T200 BALUN 11/

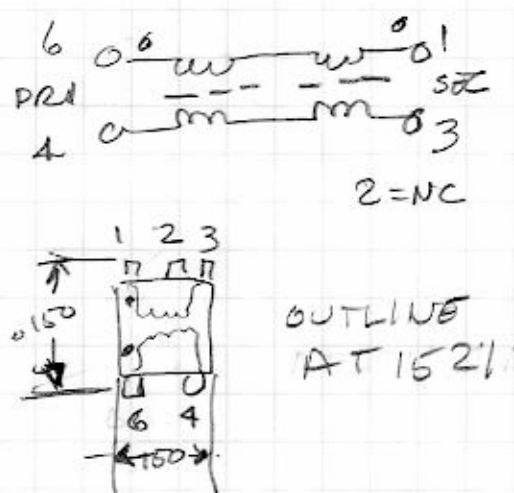
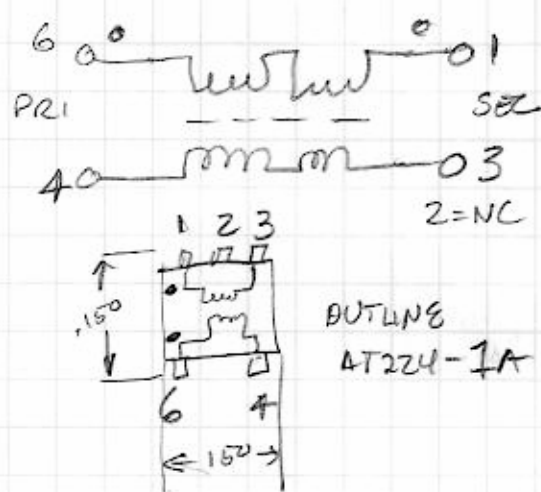
WAS:
TC1-1-43+

TO BE:
TC1-1-43X+

- ① TC1-1-43+ and TC1-1-43X+ ARE INTERCHANGEABLE FOR US
- ② WBC9-1LB CAN REPLACE TC8-1-10LN+ FOR US
 - a) 1:8 TO 1:9 RATIOS ARE COMPARABLE
 - b) Phase Reversal NOT AN ISSUE

T201, T300

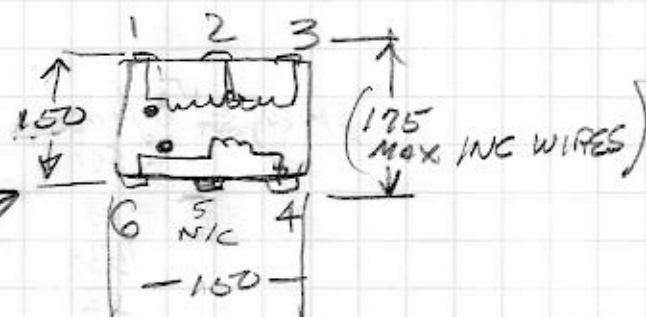
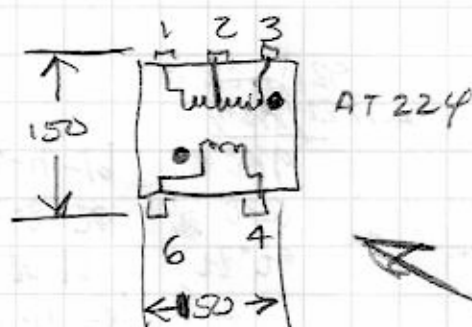
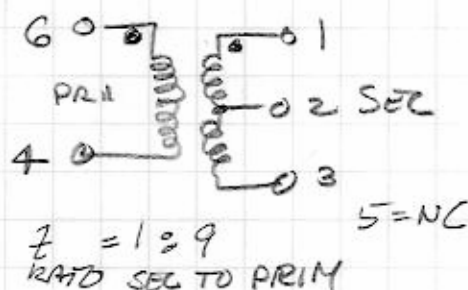
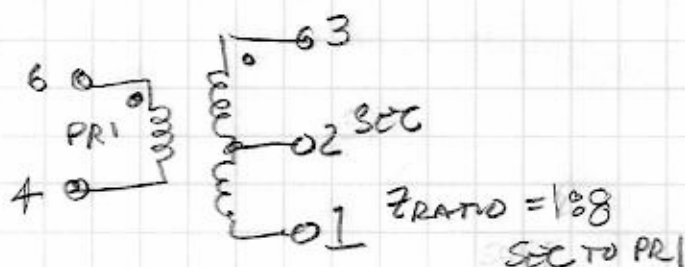
WAS:
TC8-1-10LN+

TO BE:
WBC9-1LB
(Sch 3)

Phase Reversal
